Takfot och fasad, principdetaljer 1:10

STADSDEL	FASTIGHET	DIARENUMMER	
Gamla Stan	Gamla Stan 1:34	2020-11119	
BYGGNADSTYP		STATUS	SEKVN
Nybyggnad		BYGGLOVHANDLING	
ÄRENDET AVSER, ADDRESS		BETECKNING	SKALA
Flytande badhus och multifunktionsbyggnad		Takfot och fasad - principdetaljer	1:20

Munkbrohamnen 1			
ANSVARIG ARKITEKT			
Anssi Lassila			
KONTRAKTPERSON		FIL	REV
Aki Markkanen		Takfot och fasad - principdetaljer.pdf	A
RITAD AV	DATUM	ÖMRÅDE	PROJ. NR
JP, TL	04.05.2021	ARK	1281
			NUMMER
			A-42-6-001

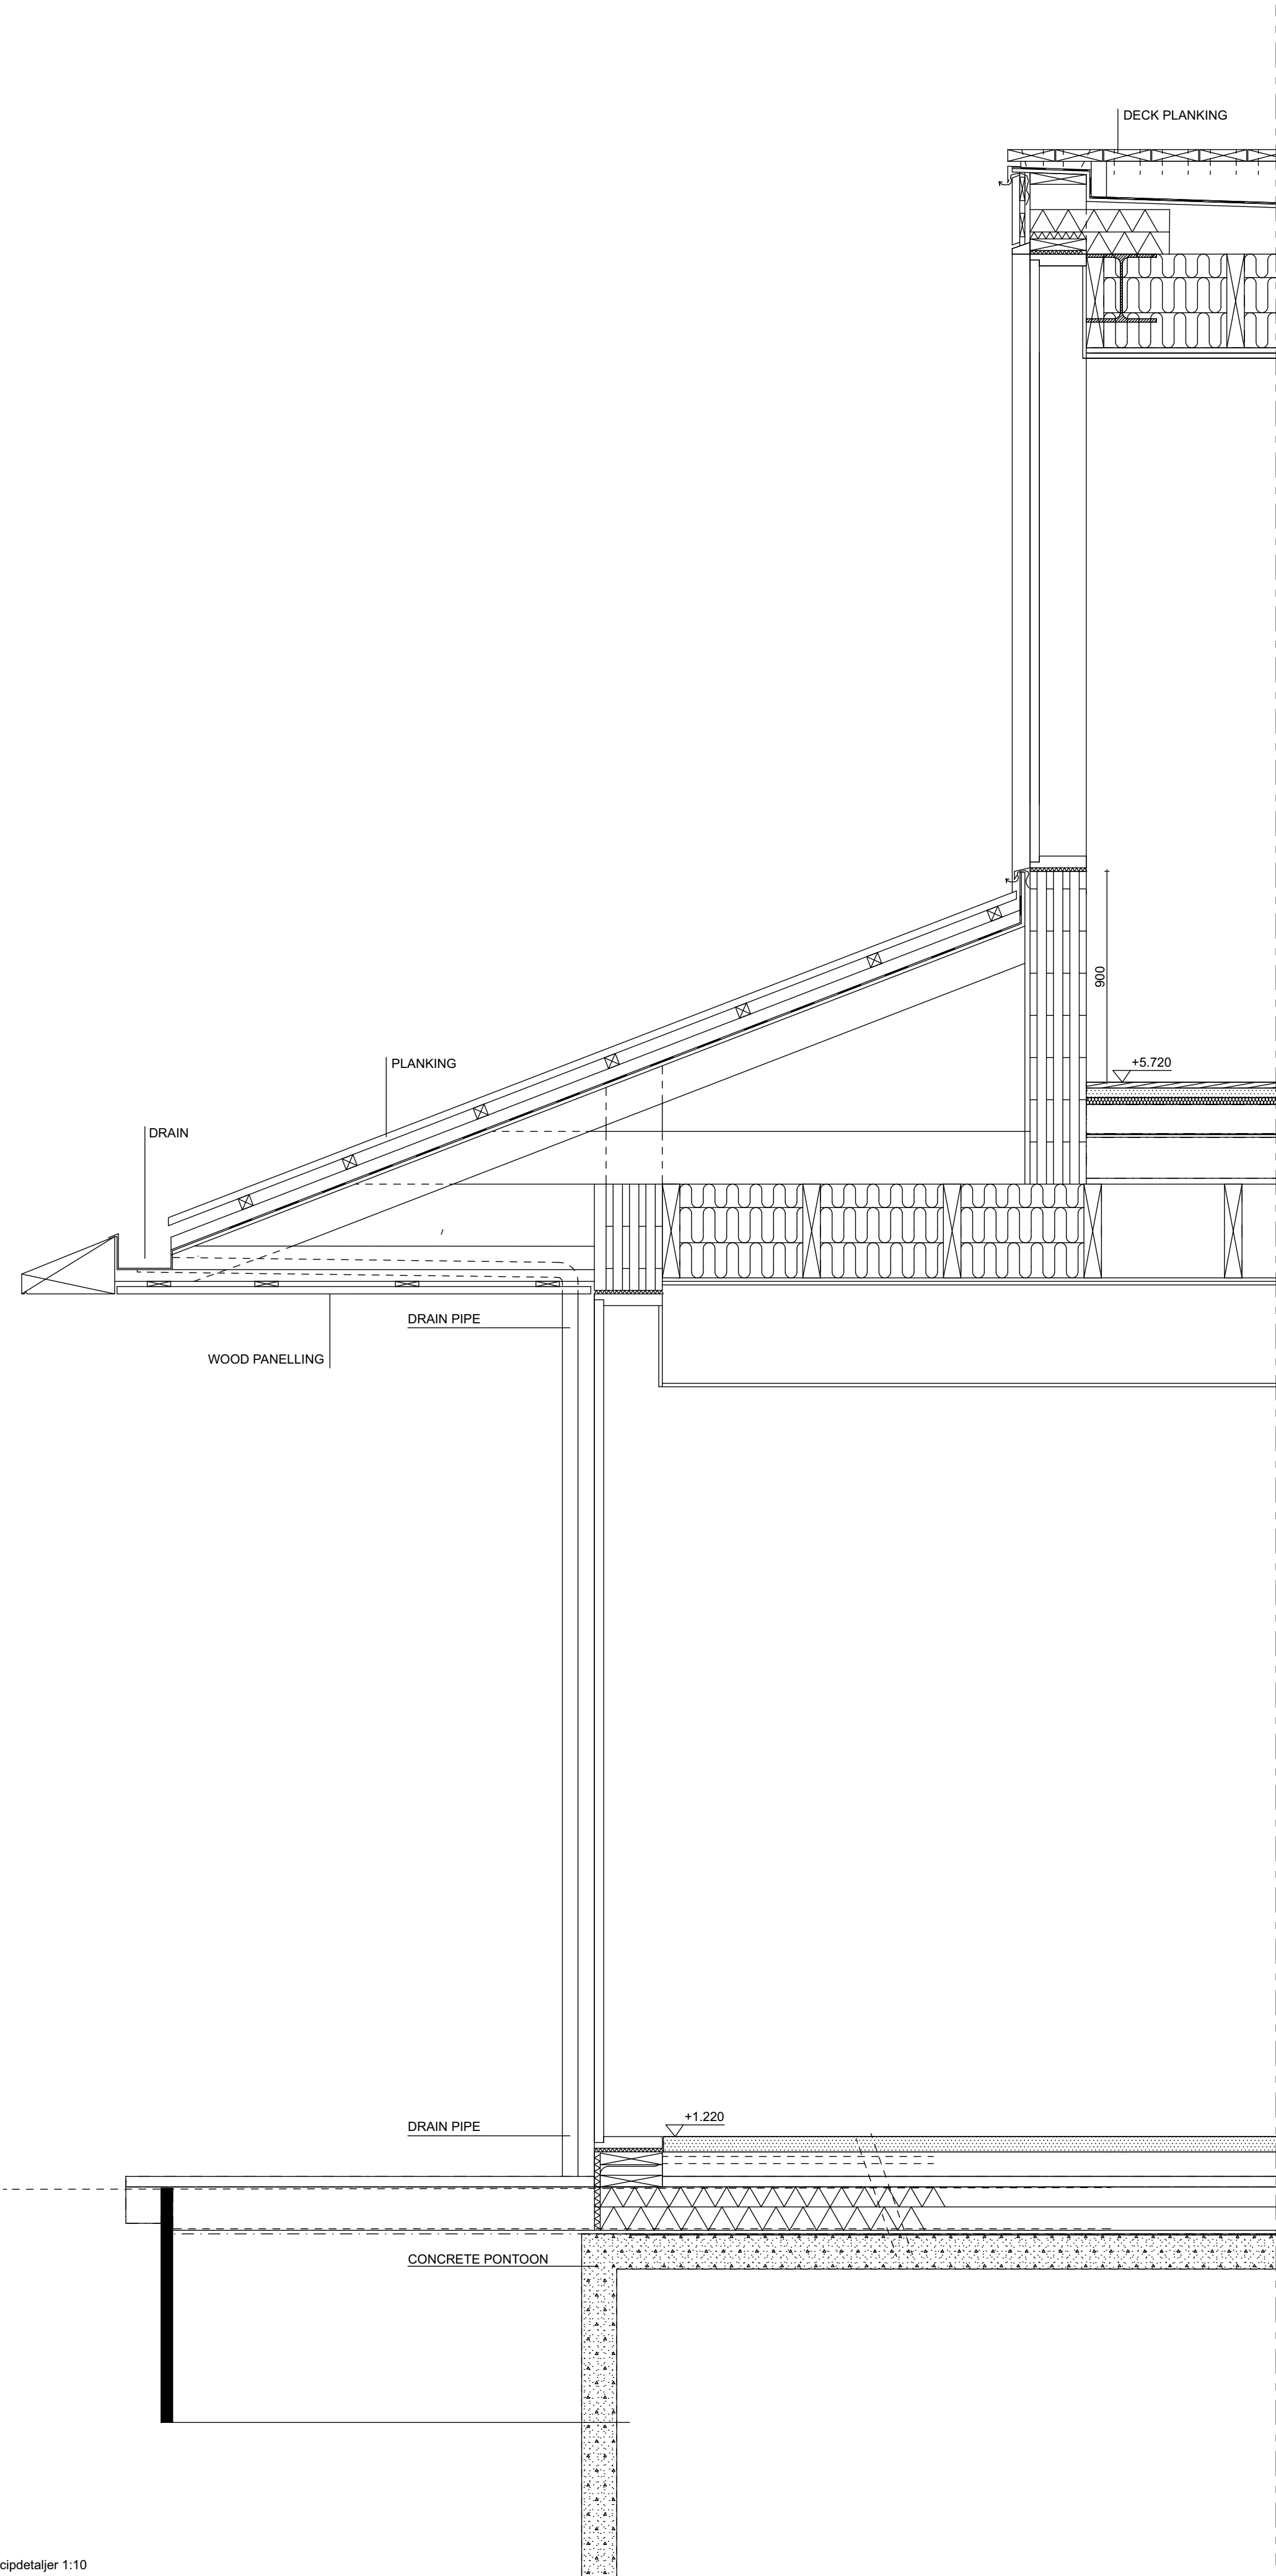
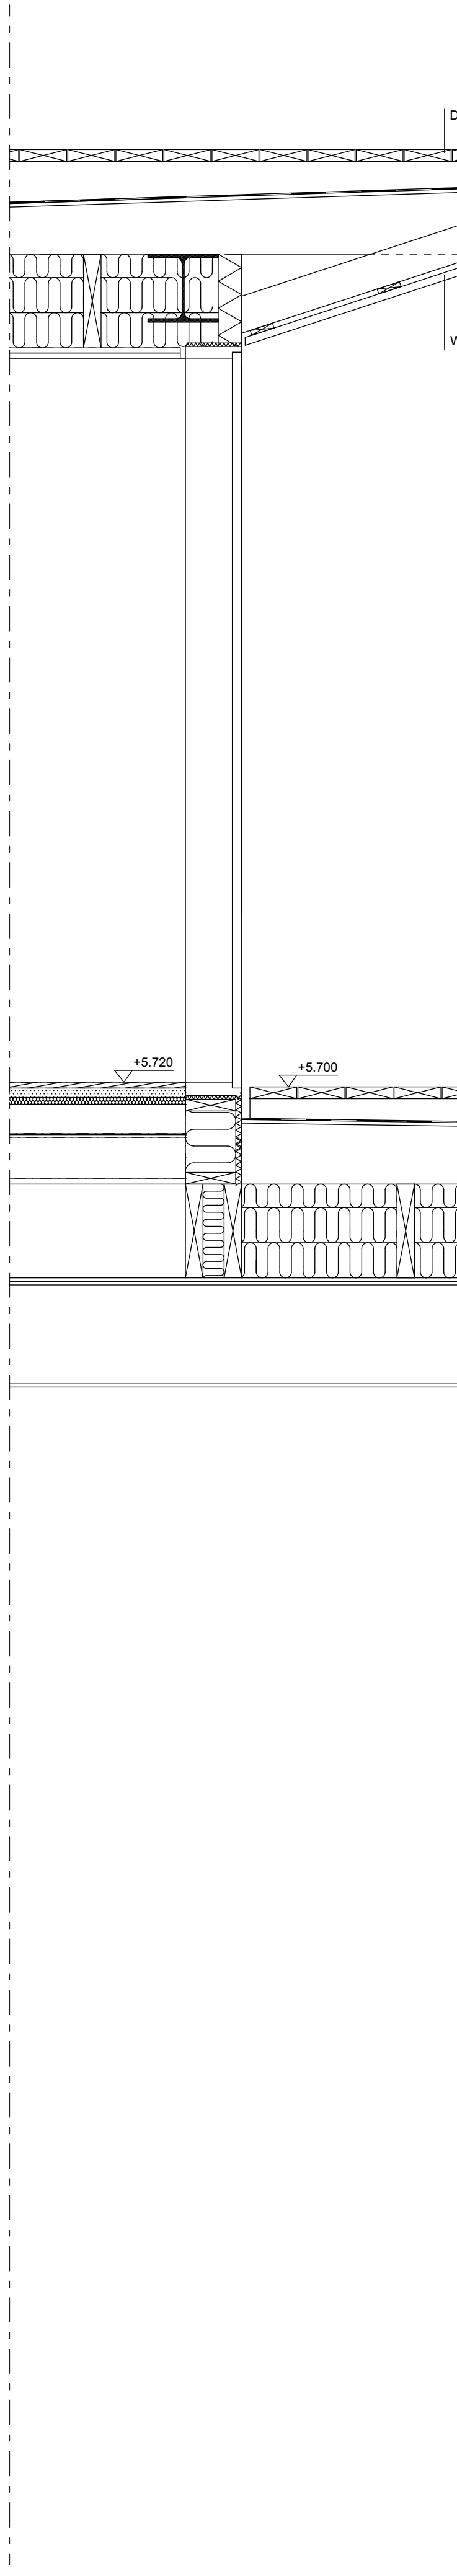
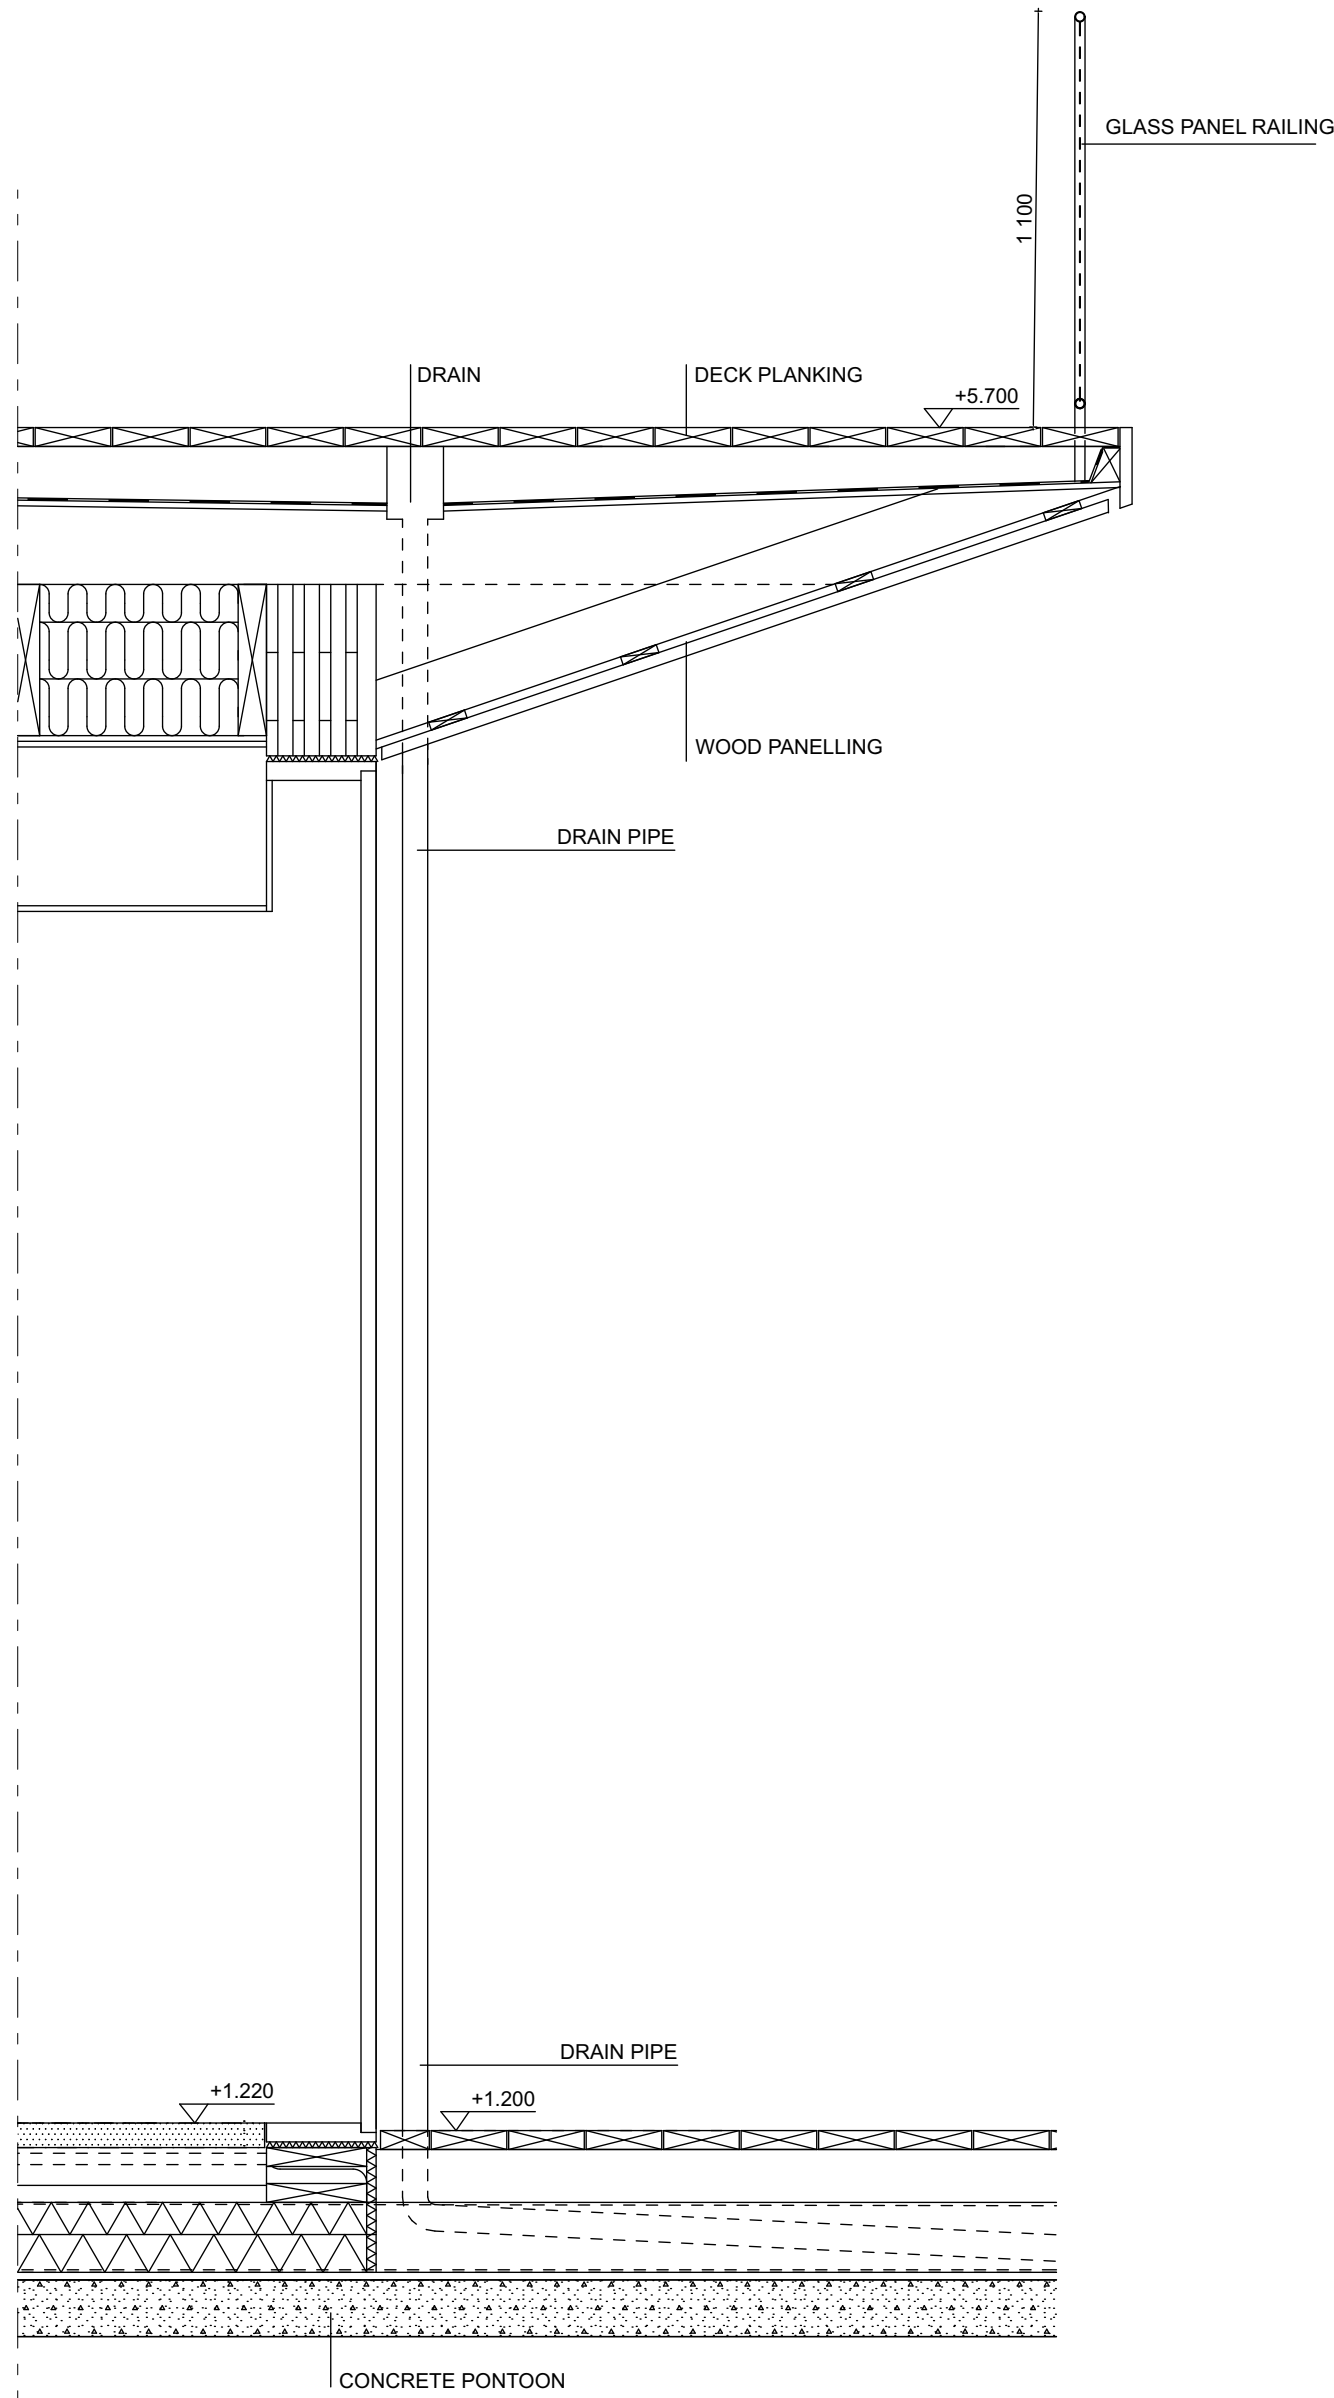
A	10.05.2021	The direction of the roof boarding of the box has been changed to vertical and the eaves detail of the box has been changed	AM
		The lower eave has been straightened	
		The eave detail above the rood window edge has been straightened vertical and the roofing blanks have been extended to meet edge
